SERVICE Counselor

PACKARD MOTOR CAR COMPANY

DECEMBER, 1952

Hand Brake Shoe Strut Lever Pin and Retainer

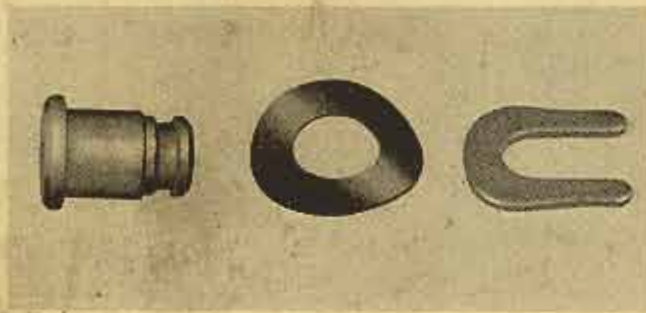
A new hand brake shoe strut lever pin, spring washer and retainer are now used in production and, also, are available for service.

The retainer is no longer made from spring steel, but is made from a thicker stock and is designed so that the open ends can be closed with a pair of pliers after it is installed on the pin. This locks the pin in place, thus eliminating the possibility of it coming out as has been encountered with the spring steel type retainer. The spring washer keeps a tension on the pin and retainer.

The new parts are available at the Parts Warehouse and can be ordered as follows:

Part No. 433270 Brake shoe strut lever pin

Part No. 446275 Brake shoe strut lever pin retainer

Part No. 446274 Brake shoe strut lever pin spring washer.

Disturbance In Reverse

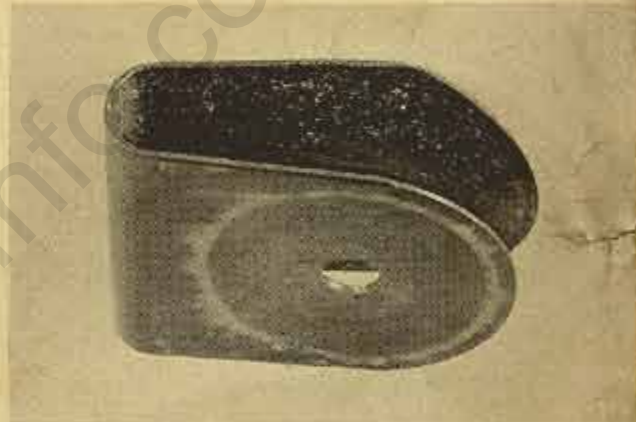
A disturbing noise when driving in reverse has been reported on a few 25th Series Ultramatic equipped cars.

During reverse operation, the rear pump is rotating in reverse direction creating a vacuum on what would be the pressure side of the pump during normal forward operation. This vacuum along with air admitted by the governor vent valve causes an aerated condition of the oil at the rear pump.

To correct this condition it is necessary to supply a greater amount of oil to the rear pump to counteract the vacuum created. This can be accomplished by drilling a $\frac{3}{32}$ " hole in the rear half (flat side) of the rear pump check valve. Insert a piece of wood between the two sides of the valve when drilling so that the shape of the valve will not be distorted. Be sure to drill the hole directly in the center to correspond to the center of the bore opening. "See illustration." Remove all burrs from the edges of the hole.

The parts listing for the rear pump check valve which incorporates the $\frac{3}{32}$ " hole has been changed to Part Number 434527, Pump Check Valve (rear).

Ultramatic Direct Drive Clutch

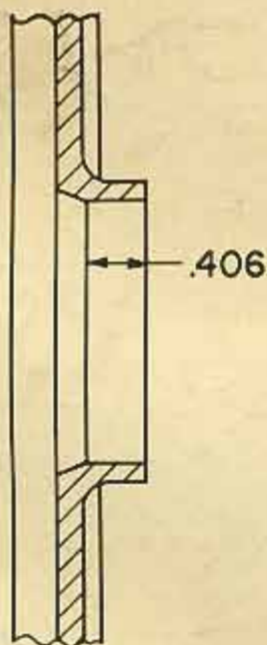
Reports have been received of the direct drive clutch failing to engage in cars having the 9 inch converter.

A direct drive clutch hydraulic pressure test generally shows the pressure is normal when the clutch starts to engage and then gradually drops off to approximately 20 lbs. This condition might also cause the clutch to slip when the engine is accelerated.

A change has been made in the machining of the inner bore of the clutch piston where it slides over the clutch housing hub and ring. The length of the bore has been increased from .281" to .406". "See Illustration".

Whenever this trouble is encountered and the hydraulic pressure to the direct drive clutch drops off, it will be necessary to replace the direct drive clutch piston with the new type.

The new type piston carries the same part number as the previous design piston which has been discontinued; however, only the new type piston is being furnished by the Parts Warehouse, which may be ordered under Part No. 423413 Converter Clutch Piston.

High Range Clutch Lubrication and Operation

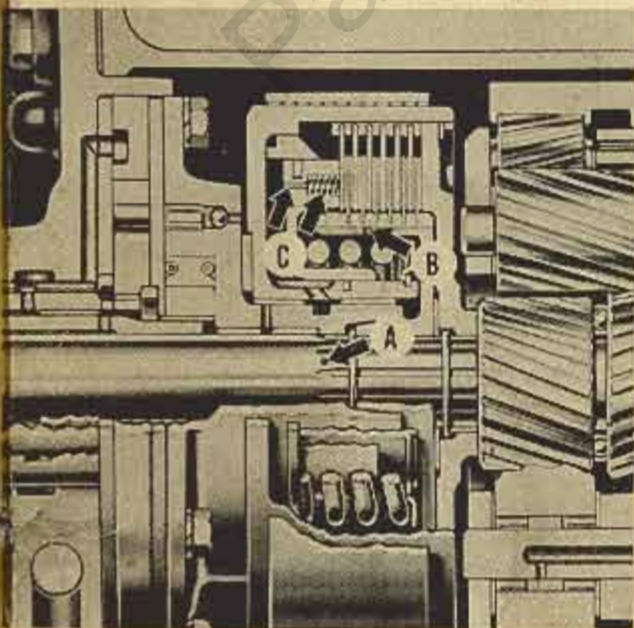
1. A $\frac{3}{32}$ " hole "A" has been added in the end of one of the input shaft splines. Fluid is forced from this passage past the front pump rear extension and

input shaft front snap ring into the clutch hub where the clutch spring is located.

2. Twenty $\frac{3}{32}$ " holes "B" have been drilled through the outer portion of the clutch hub, these holes are spaced around the hub so that fluid can be forced between each plate.

3. The clutch piston vent springs and vent holes "C" have been eliminated, therefore, the venting is accomplished through the outer ring gap. This change in venting provides quicker high range clutch engagement.

NOTE: It is very important that the high range clutch piston outer ring gap be held to a .007" to .012" clearance.

These changes may not all go into production at the same time. In service replacement no harm will come from having new type and old type parts in the same transmission.
